RESOLUTION AFFIRMING THE DECISION OF THE CITY PLAN AND ZONING COMMISSION TO CONDITION APPROVAL OF THE SITE PLAN FOR A NEW CASEY'S CONVENIENCE STORE AT 6120 DOUGLAS AVENUE UPON PROVISION OF ALLOWANCE FOR FUTURE VEHICULAR ACCESS TO THE ADJOINING PROPERTY TO THE WEST

APPROVAL of a request from Casey's Marketing Company (developer) represented by Michael R. Richardson (officer) for review and approval of a Site Plan under design guidelines for convenience stores and gas stations on property located at 6120 Douglas Avenue, to allow development of a 3,920 square-foot convenience store with a 7,524 square-foot pump island canopy and 16 fueling stations subject to the following: 10-2010-7.22

STAFF REPORT

1 Left Side Elevation

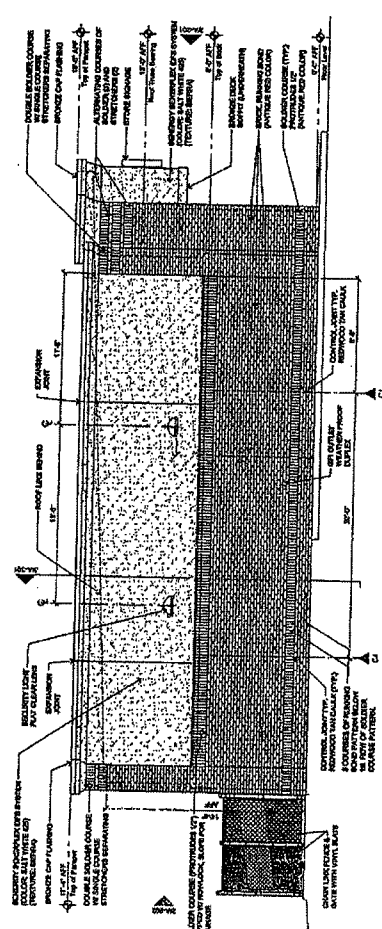
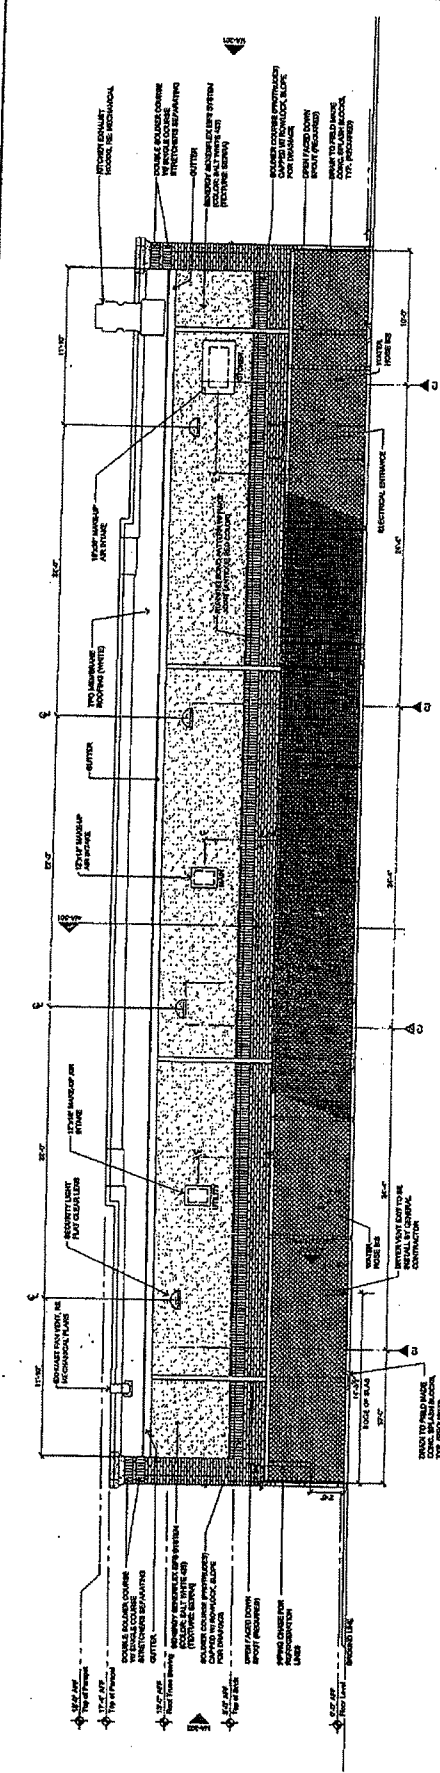
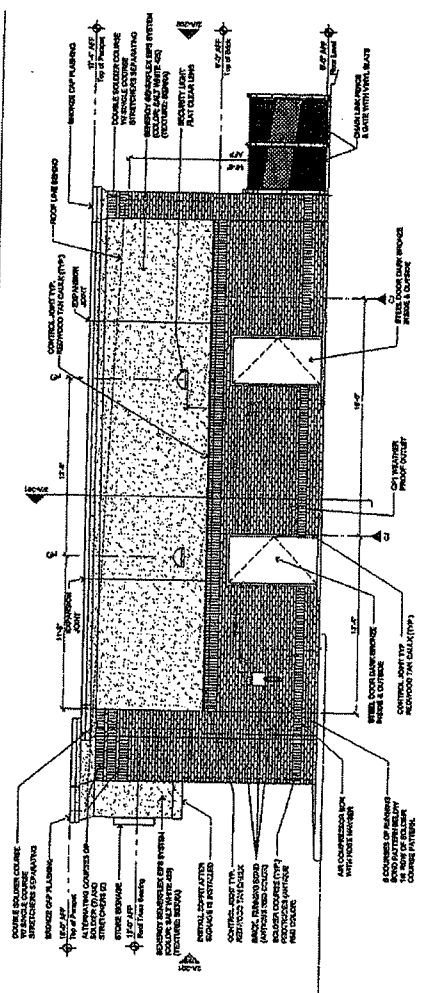
Staff believes that the articulated, brick exterior base and EIFS paneling proposed on the all sides of the building is appropriate for the neighborhood and meets the intent of the guideline.

The proposed building is comprised primarily of brick on all four facades with EIFS paneling on upper portions of the walls.

The proposed design incorporates a molded cornice treatment above the roof parapet with soldier courses of brick at the tops of the wall columns.

The proposed design uses horizontal brick soldier coursing, brick column fenestration, variation in the roof line and an articulated molded cornice parapet design to comply with this guideline.

1 Dumpster Plan
18'-0\"/>

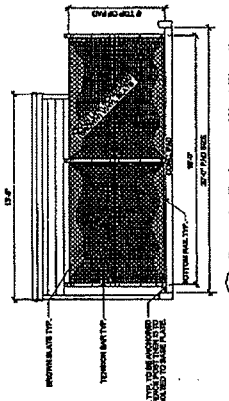
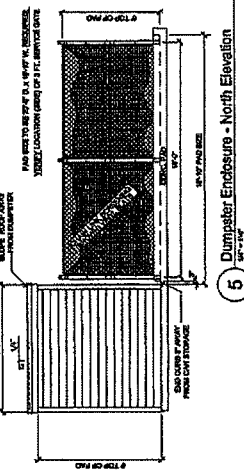
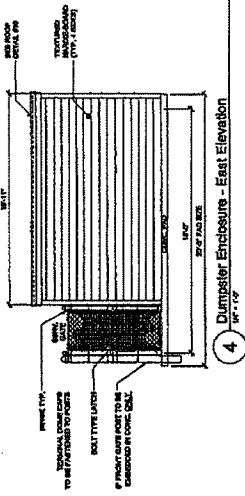
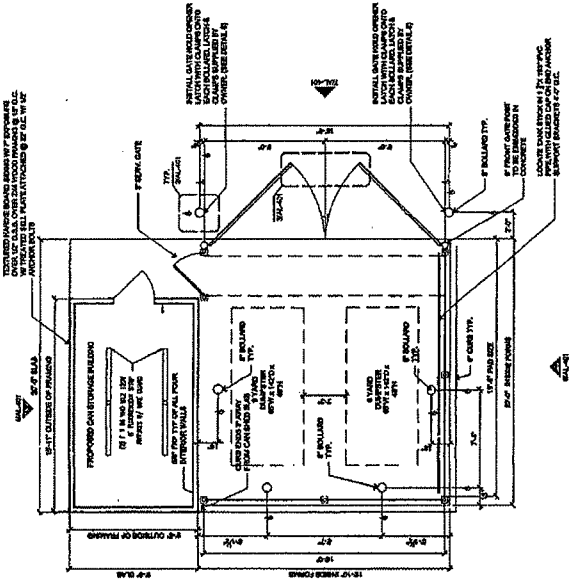
However, the proposed chain-link screens for the trash enclosure and mechanical equipment to the rear of the building are not adequate. Any trash enclosure should be architecturally compatible with the primary building with durable opaque metal gates. Staff also does not believe the chain-link fencing with slats is the most appropriate method for screening the mechanical units on the south side of the building which is oriented toward the residential neighborhood. Either a site wall to match the architecture of the building, a solid wood fence, or a dark solid vinyl or metal panel screening system would all be more appropriate alternatives.

4. Modification of the proposed trash enclosure and can recycling shed designs to be architecturally compatible with the primary commercial building. The trash enclosure shall have opaque metal gates.
